UNITED STATES PATENT AND TRADEMARK OFFICE

APPLICATION NO.	FILING DATE	FIRST NAMED INVENTOR	ATTORNEY DOCKET NO.	CONFIRMATION NO.
10/622,446	07/21/2003	Gregory Tuc	116640	5233
25944	7590	12/28/2004		
OLIFF & BERRIDGE, PLC P.O. BOX 19928 ALEXANDRIA, VA 22320				EXAMINER FERGUSON, MICHAEL P
				ART UNIT 3679 PAPER NUMBER

Office Action Summary	Application No.	Applicant(s)	
	10/622,446	TUC ET AL. <i>[Handwritten Signature]</i>	
	Examiner	Art Unit	
	Michael P. Ferguson	3679

DETAILED ACTION

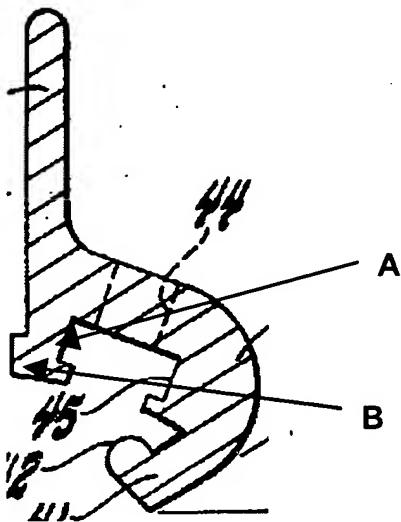
a fixing tab **33,42** suitable for engaging in a slot **29** of the tubular element;
an opening allowing a screw shank **52** to pass through for holding the panel; and
a face for pressing against one side of the panel and comprising stiffening ribs
32,34,A,B (Figure 6 reprinted below with annotations; Figures 5-7).

Examiner disagrees. As to claim 11, Trafton discloses a fixing element **30,40** comprising a face comprising a stiffening rib **32,34,A,B** (Figures 5 and 6).
